MODBAR TECHNICAL BULLETIN
#33
steam module drain hose

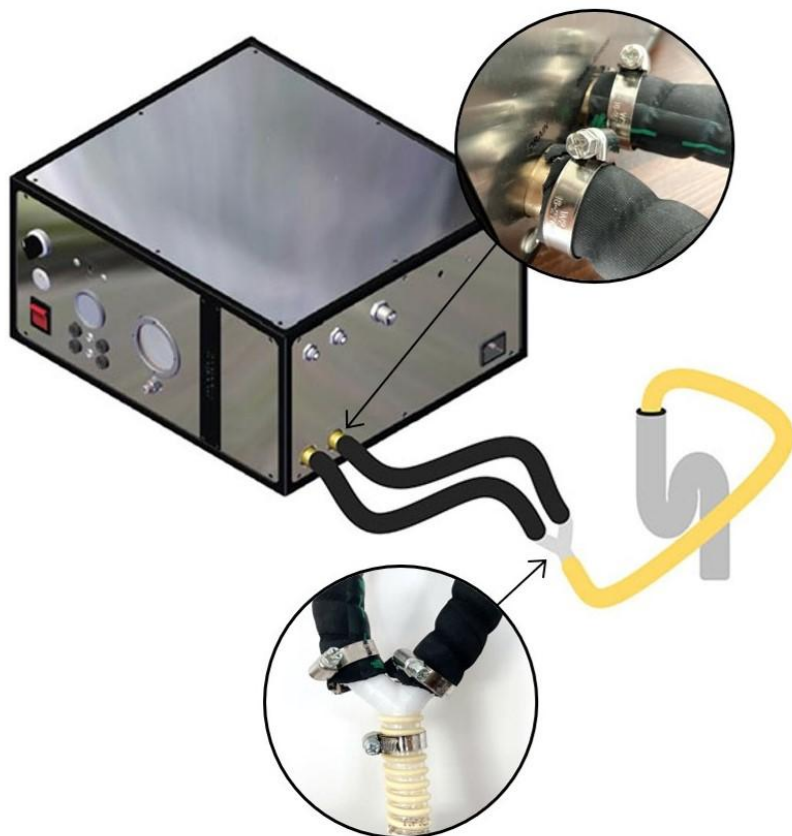
starting from s/n MB002463, all modbar steam modules include a new drain hose in addition to the usual one.

The new hose is high-temperature resistant and it's designed to be attached directly to the module's drain outlets, where we've found that the extreme heat can damage the normal hose.

It's pre-cut in two pieces, which can be joined using the supplied "Y" manifold to the other hose if an extension is needed.

Please be aware that this new hose is stiffer and also extremely difficult to be cut on-site with normal cutters or wire-cutters, as it's made of thick EPDM and reinforced with a very strong steel wire.

Should you need a shorter drain hose or, for any reason, not be able to use the new type of hose, we suggest you to continue using the normal hose and to check its conditions often. We understand that the excessive stiffness and the difficulty of cutting the hose may make it unsuitable for some installations. We are working hard and are confident towards finding a more practical solution soon, to better suit all possible installation scenarios.

The new EPDM drain hose is also available as a spare part with code T.3.010 (length must be specified in the order).
